CITY PLAN COMMISSION STAFF REPORT

CD-CPC-2026-00023

5019 Raytown Road

Plan Conditions, Corrections, & Suggestions Report

EXTERIOR ELEVATIONS

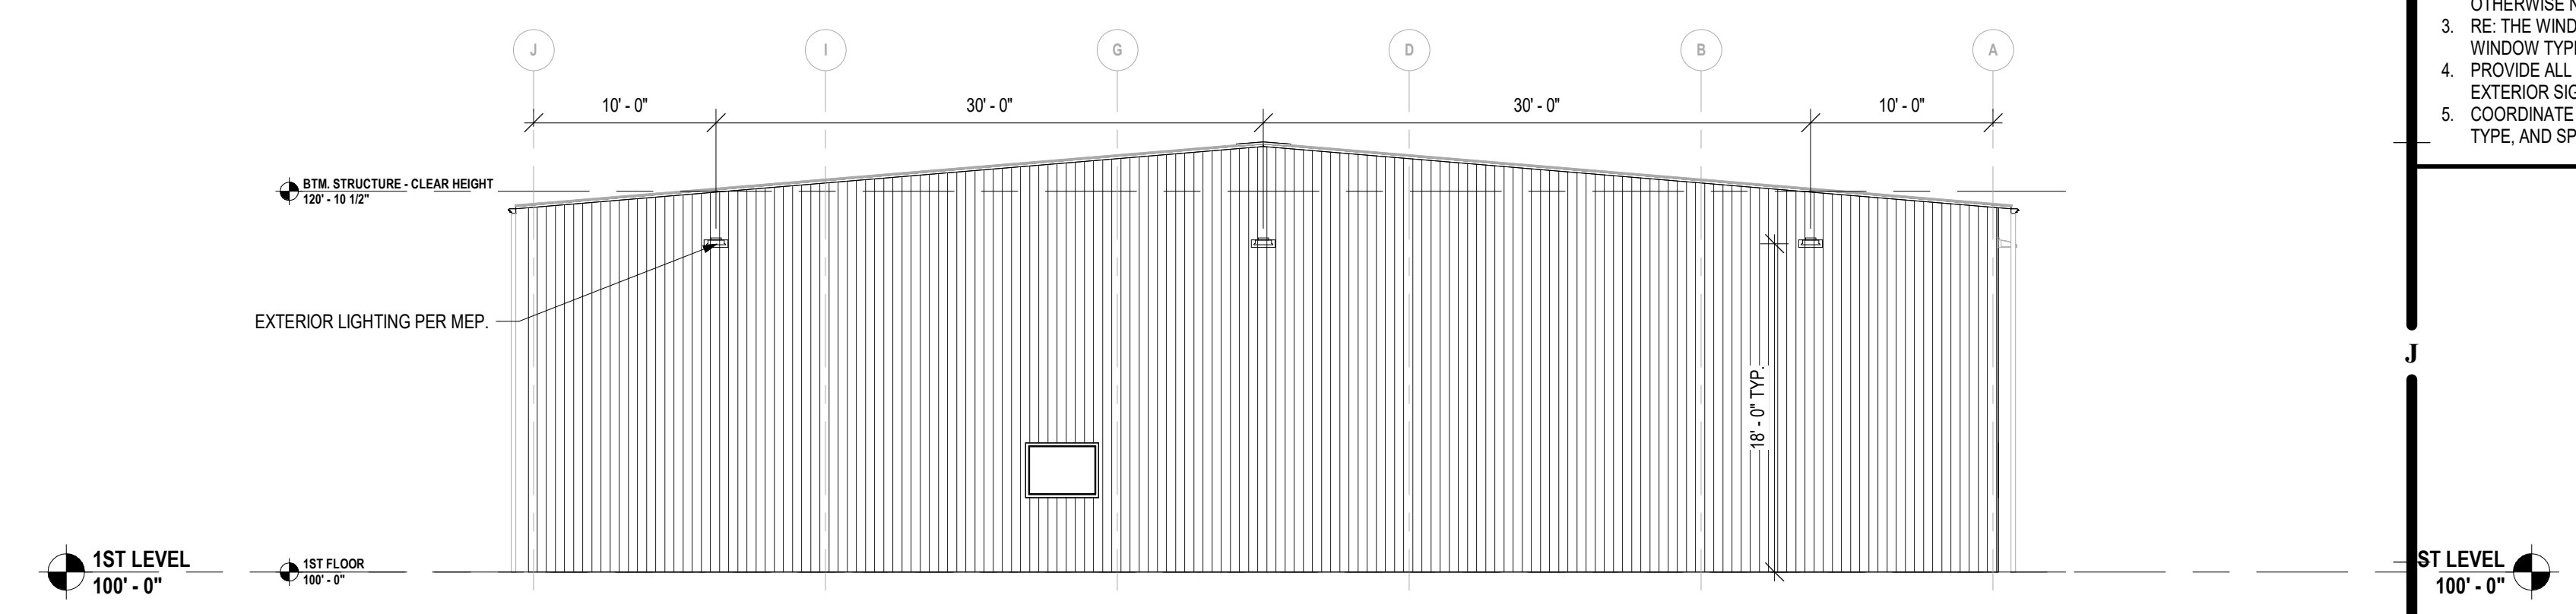
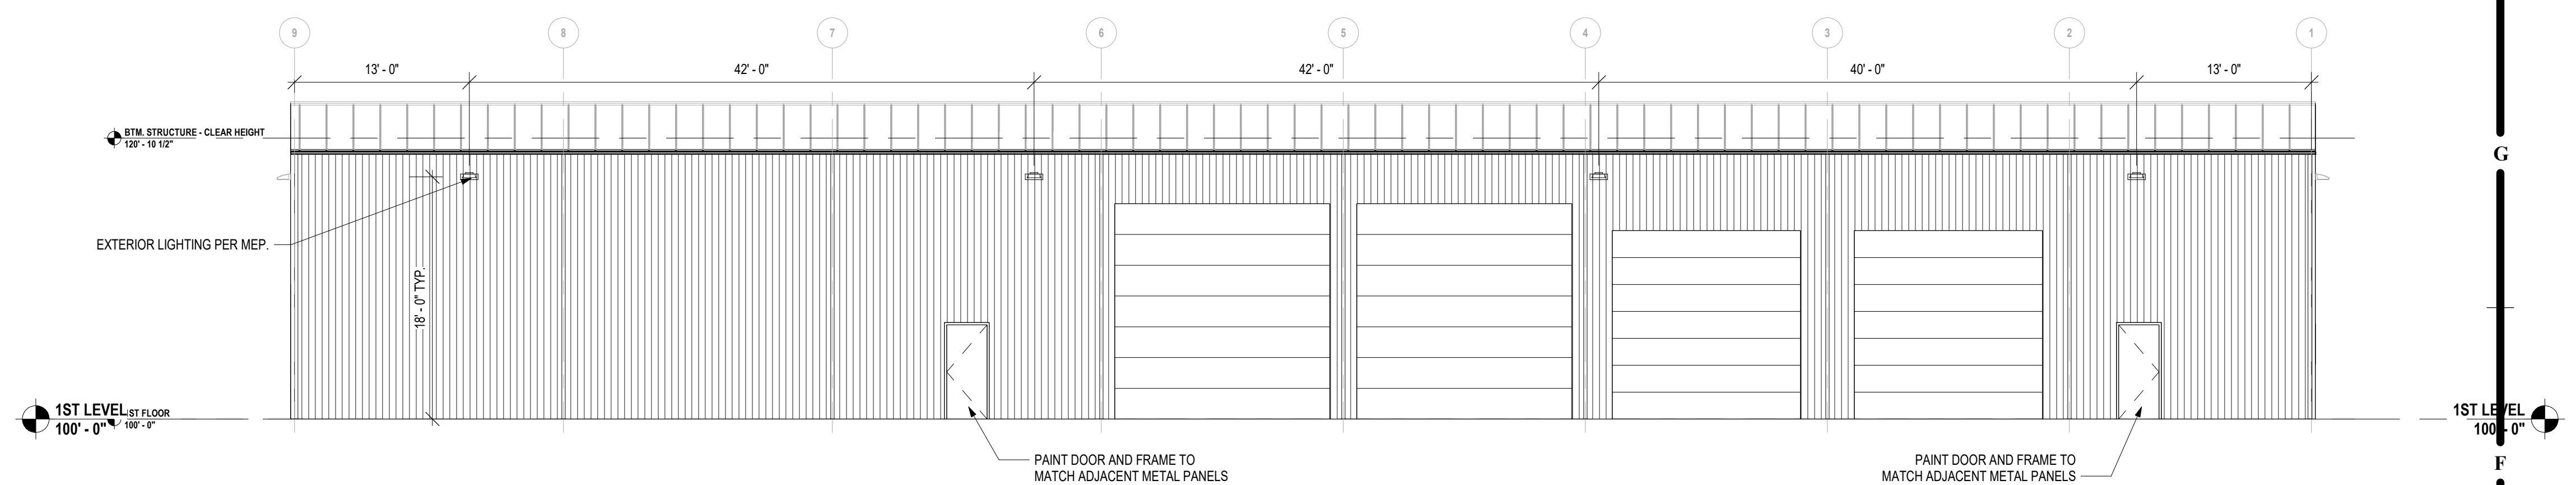
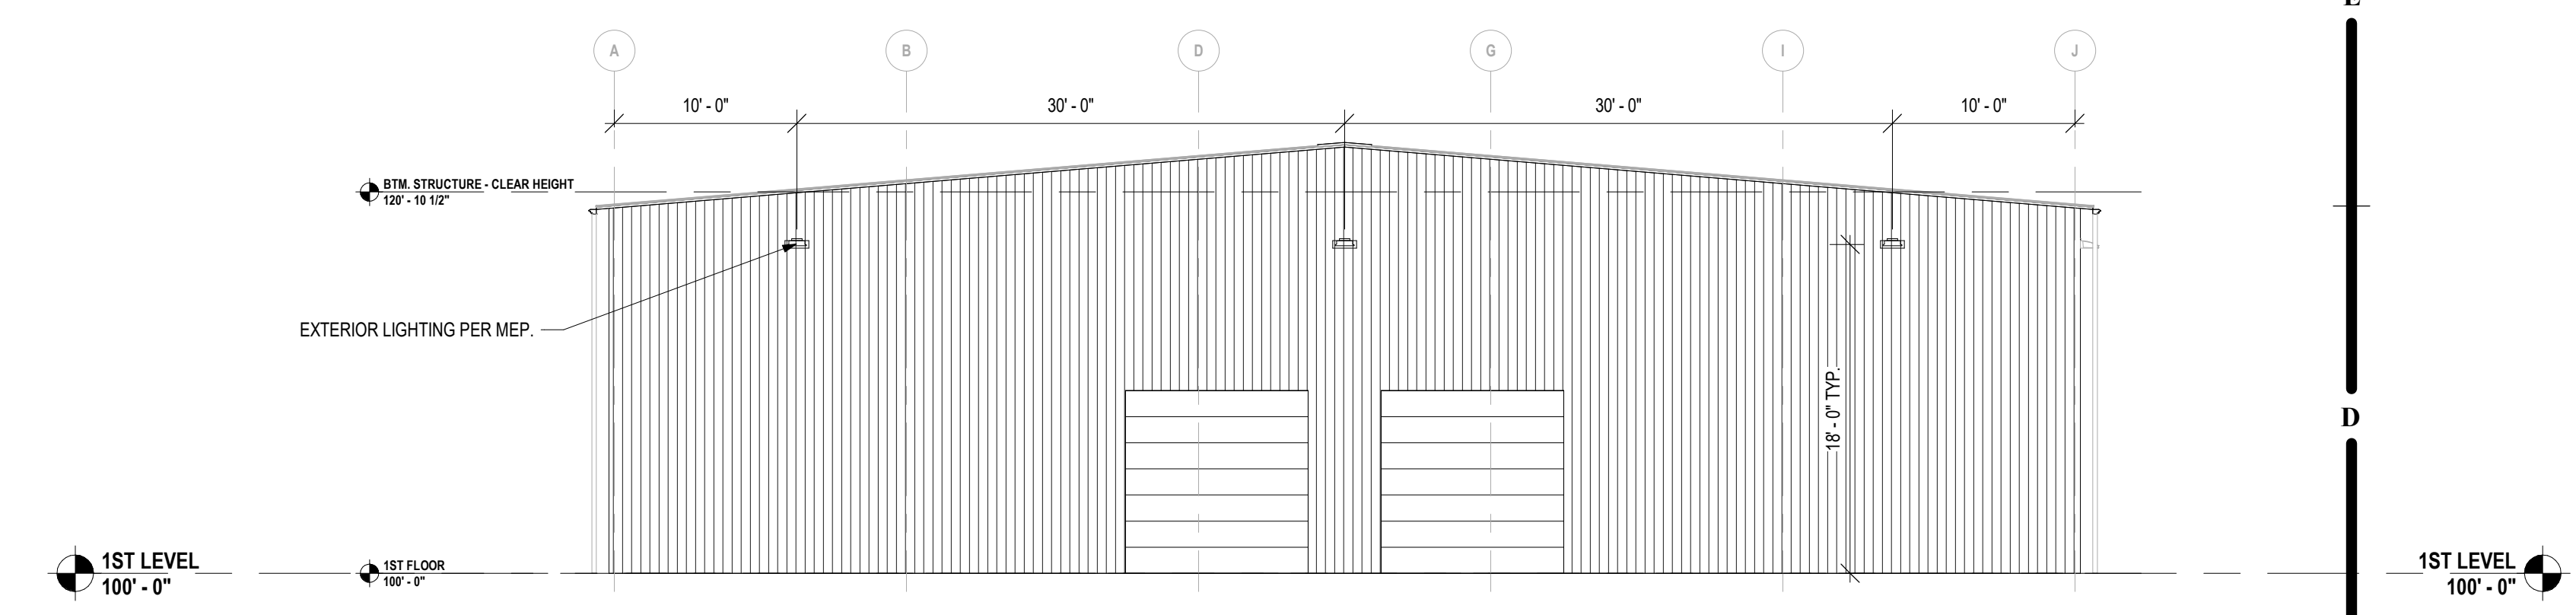
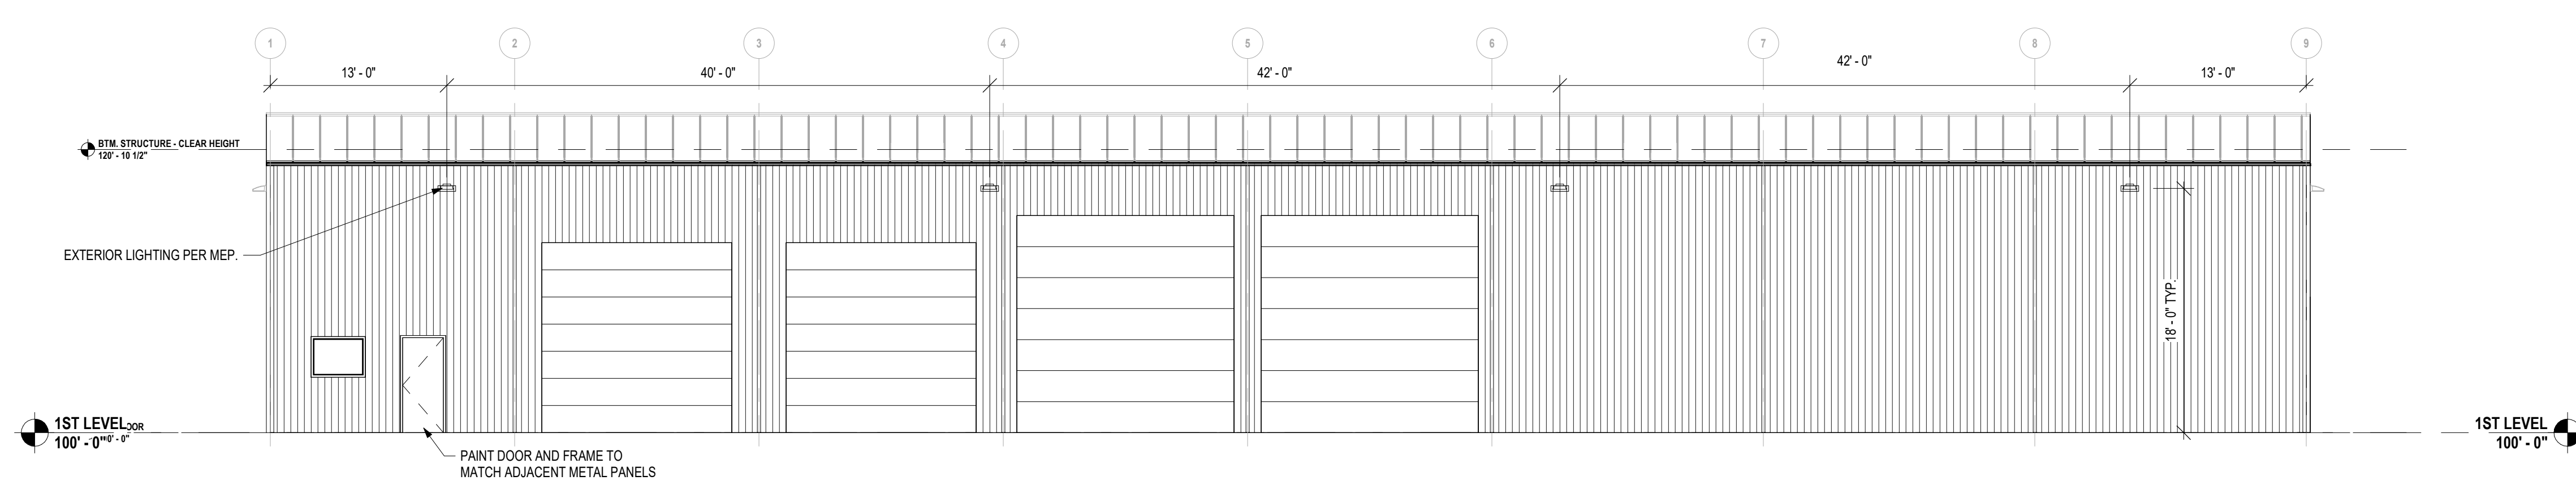
15. The applicant shall revise the building elevations to apply high quality building materials including but not limited to brick, stone, cast stone, finished concrete, stucco (not EIFS), metal (not sheet or pan style), or cement board to the front facade of the proposed building facing Raytown Road to increase alignment with design guidelines in the area plan and KC Spirit Playbook and Raytown Road's identified Image Street status. This shall be completed prior to ordinance request. (4/03/2026)

16. The applicant shall revise elevations to add eye-level windows with two-way transparency, clerestory windows, or material changes to the front facade of the proposed building facing Raytown Road to better align with the Well-Designed City goal of the KC Spirit Playbook. Denote on the elevations the material type and location on the elevation drawings. This shall be completed prior to ordinance request. (4/03/2026)
